**To:** ICC-ES Evaluation Committee  
**From:** Mahmut Ekenel and Russ Krivchuk, ICC-ES Staff  
**Date:** June 10, 2010  
**Subject:** Proposed Acceptance Criteria for Continuous and Semicontinuous  
Fiber-reinforced Grid Connectors Used in Combination with Rigid  
Insulation in Concrete Sandwich Panel Construction, Subject  
AC422-0610-R2 (ME/RK)

**MEMO**

# PROPOSED ACCEPTANCE CRITERIA FOR CONTINUOUS OR SEMICONTINUOUS FIBER-REINFORCED GRID CONNECTORS USED IN COMBINATION WITH RIGID INSULATION IN CONCRETE SANDWICH PANEL CONSTRUCTION

AC422

FIGURE 2 — TYPICAL DOUBLE-SHEAR SPECIMEN

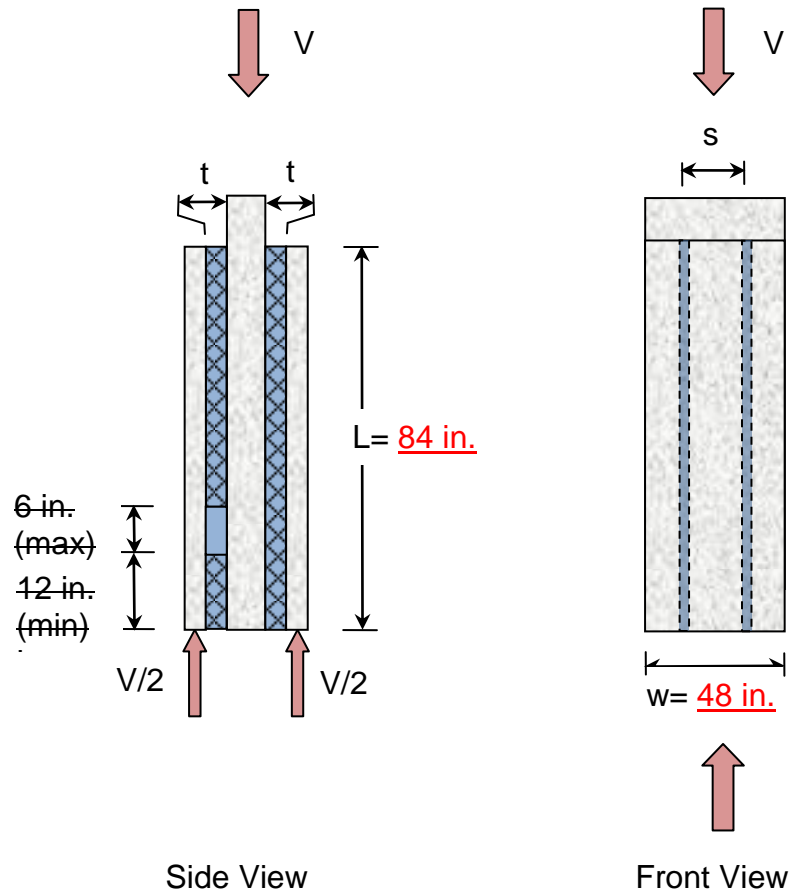
6. This comment is related to item no. 6 of the staff letter dated May 13, 2010. Staff acknowledges item no. 3 of the Thermomass letter, dated June 1, 2010, which states that the test, as currently described in Figure 2 of the proposed criteria, will tell us the behavior of neither continuous grid nor semicontinuous grid. Staff shares this concern and questions the purpose of testing of the specimen containing a combination of continuous and semicontinuous grids. It is the ICC-ES staff recommendation that Figure 3 be revised to indicate continuous grids only.

10. Staff proposes an amendment to Section 4.2 by adding the following sentence:  
Insulation material shall be recognized in a current ICC-ES evaluation report.
11. The Thermomass letter dated June 1, 2010, raises a question in regard to cracked versus uncracked concrete. Staff's opinion is that Sections 6.11 and 6.7 address this concern.
12. Staff proposes revisions to Figure 2 of the draft criteria with the addition of  $L = 84$  inches and  $w = 48$  inches.

**FIGURE 3 — TYPICAL DOUBLE-SHEAR SPECIMEN UNDER LOAD**

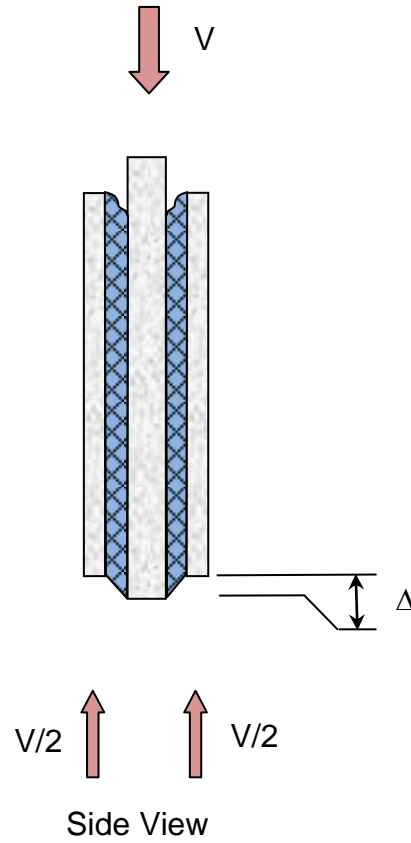
1. This comment is related to item no. 1 of the staff letter dated May 13, 2010. It is staff opinion that due to the test configuration in Figure 3 of the draft criteria, a shorter height may adversely affect test results, resulting in lower design values. Therefore, staff recommends that a condition of use be added to Section 6.0 of the criteria limiting the end use of the product to panels with a minimum span of 7 feet, as follows: The minimum span of panels with fiber-reinforced grid connectors is limited to 7 feet.
